Addendum to the
Environmental Impact
Assessment Report

NISA
North Irish Sea Array

Appendix A5.1

Design Refinements

Image A2.1: Refinement of WTG Layout Options for Project Option 1

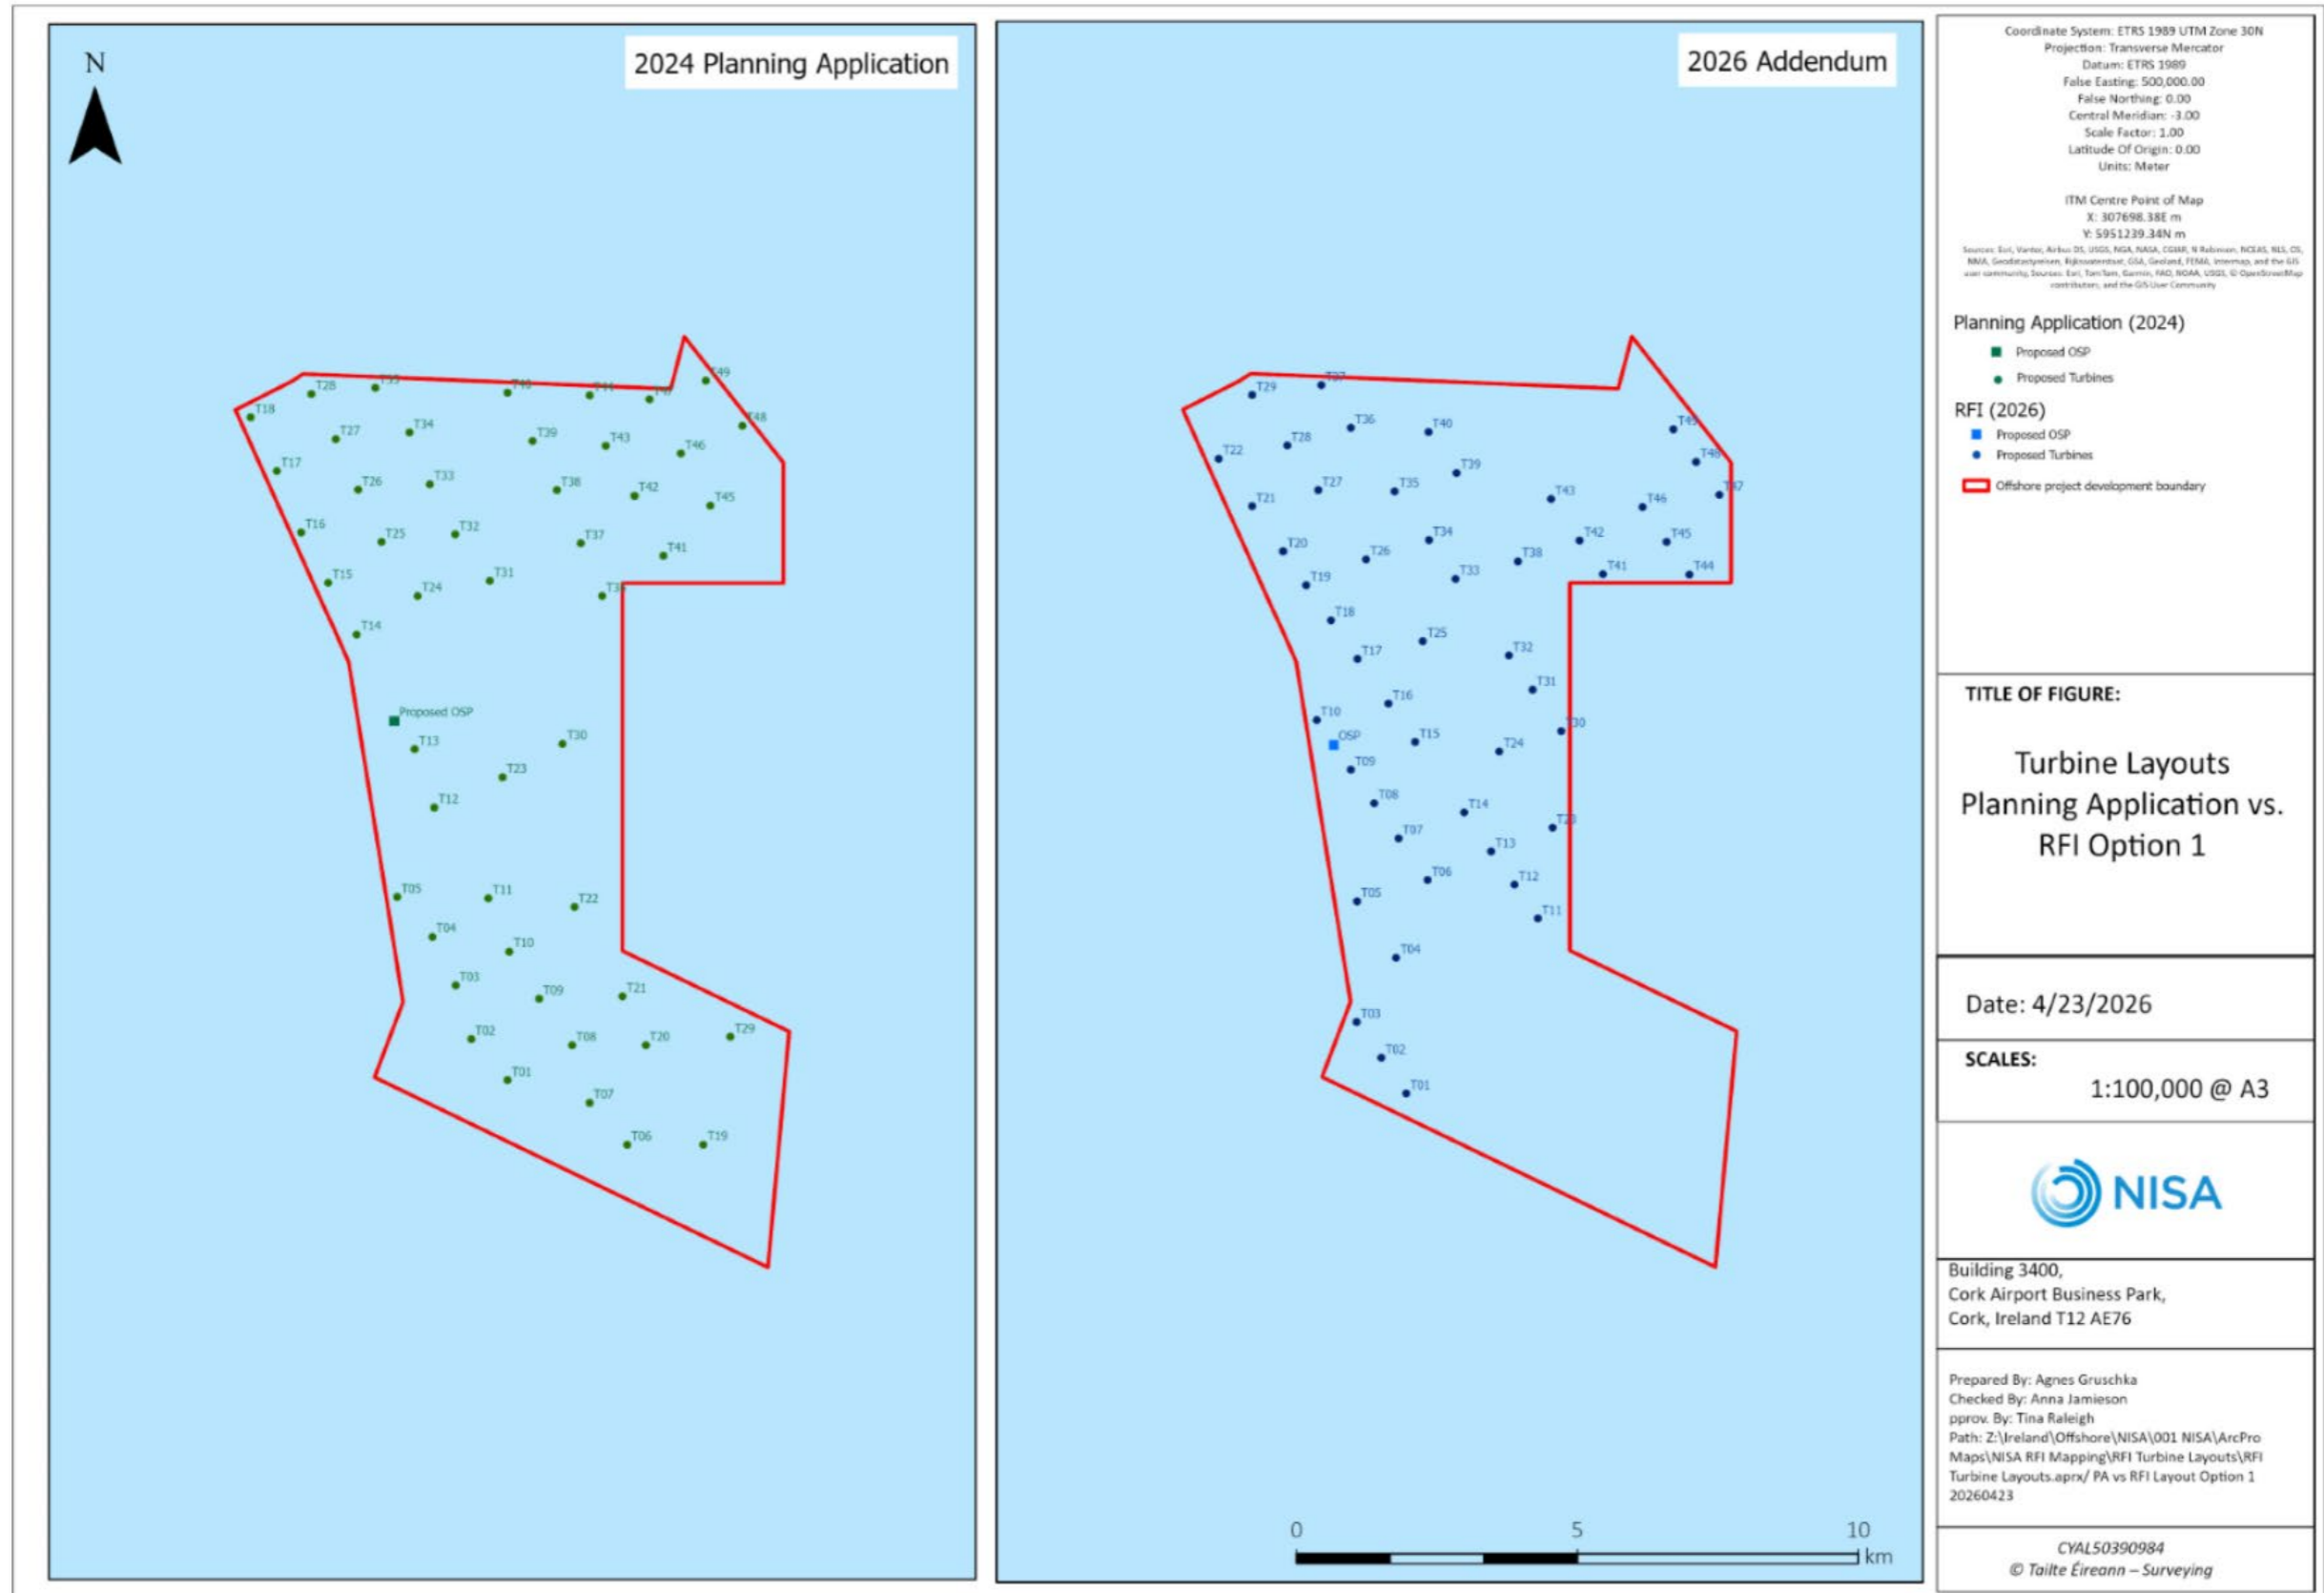
1. Refinement of WTG layouts for Project Option 1 and Project Option 2 (Images A2.1 and A2.2), to address stakeholder (IRCG and MSO) concerns around navigational safety and offshore infrastructure footprint;

- 2a - IRCG raised concerns in relation to the layout of the proposed development with respect to search-and-rescue (SAR) access. This has been addressed and accepted by IRCG by updating WTG layouts for Project Option 1 and Project Option 2.

- 2b - the Marine Survey Office (MSO) disagreed with the summarisation of the risk to the safety of navigation posed to commercial shipping, fishing vessels, and recreational craft transiting in proximity to the southeastern corner and the Rockabill GAP. This has been addressed and accepted by MSO by updating the WTG layouts for Project Option 1 and Project Option 2, to increase the Rockabill GAP and to reduce the infrastructure in the south east corner.

Image A2.3: Jacket foundation on suction buckets and jacket foundation on pin piles

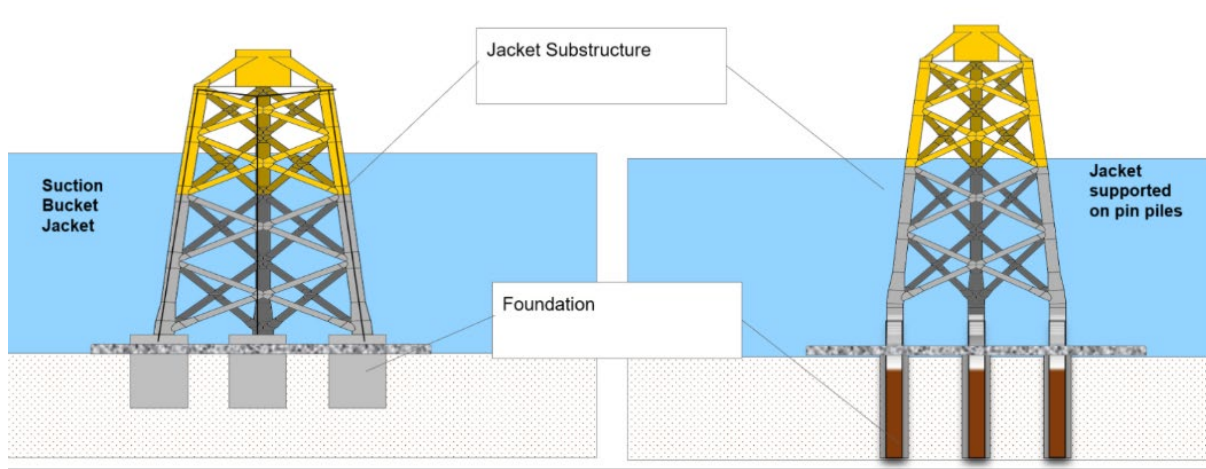
2. Removal of both driven and drilled monopile foundations and jackets with pin pile foundations as options for WTG installation from Project Option 1 and Project Option 2, and a refinement to the WTG foundation installation methodology to jackets with suction buckets (hereafter referred to as 'SBJs') for Project Option 1 and Project Option 2³ to address key stakeholder (NPWS) concerns in the RFI around underwater noise. Suction buckets are a low underwater noise solution⁴ for WTG installation and a proven technology on other wind farms⁵ (See image A2.3 for details of suction bucket technology);

3. Removal of monopile foundations for the Offshore Substation Platform (OSP), and refinement of the OSP foundation installation to SBJs or jackets with drilled pin piles, which significantly reduces potential underwater noise effects during construction from piling activities and responds to key concerns from NPWS on this matter within the RFI; and
